# City of Lee's Summit

October 19, 2018

TO: Planning Commission  
PREPARED BY: C. Shannon McGuire, Planner  
CHECKED BY: Hector Soto, Jr., AICP, Current Planning Manager  
RE: **CONTINUED PUBLIC HEARING – Appl. #PL2018-079 – REZONING from AG to RP-4 and PRELIMINARY DEVELOPMENT PLAN – Artisan Point Apartments, approximately 35 acres generally located at the northeast corner of SE Blackwell Rd and SE Blue Pkwy; Case Development, LLC, applicant**

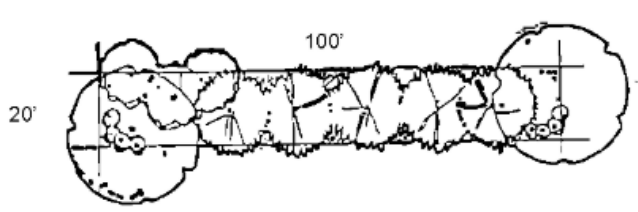
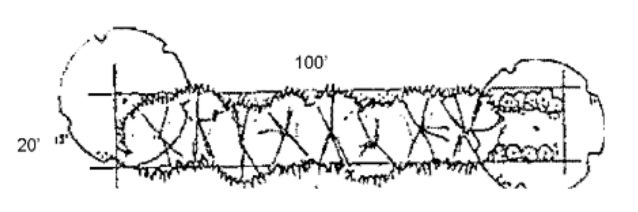
- Proposed – The applicant proposes to install a medium impact screening landscaping buffer along the northern property line. The medium impact landscape screen will meet one of the options as outlined in Article 8 of the UDO. The tables below outline the screening options as required by the UDO and provides a visual representation for each.

- Recommended – The medium impact screening will provide a 70 percent semi-opaque screen between land uses which are dissimilar in character. This semi-opaque screening will partially block views from adjoining land uses and create a separation between the adjoining properties. The applicant proposes to set the apartment buildings back from the northern property line approximately 135' to 204'. In addition to the proposed landscaping buffer the applicant has located the required storm water detention basin between the proposed buildings and landscaping buffer thus creating an additional buffer between the land uses. As seen in the below illustration, with the significant distances, a six (6) foot fence will have a negligible effect in providing a screen to the nearby residential homes. For these reasons staff believes the proposal to be reasonable and supports the requested modification.
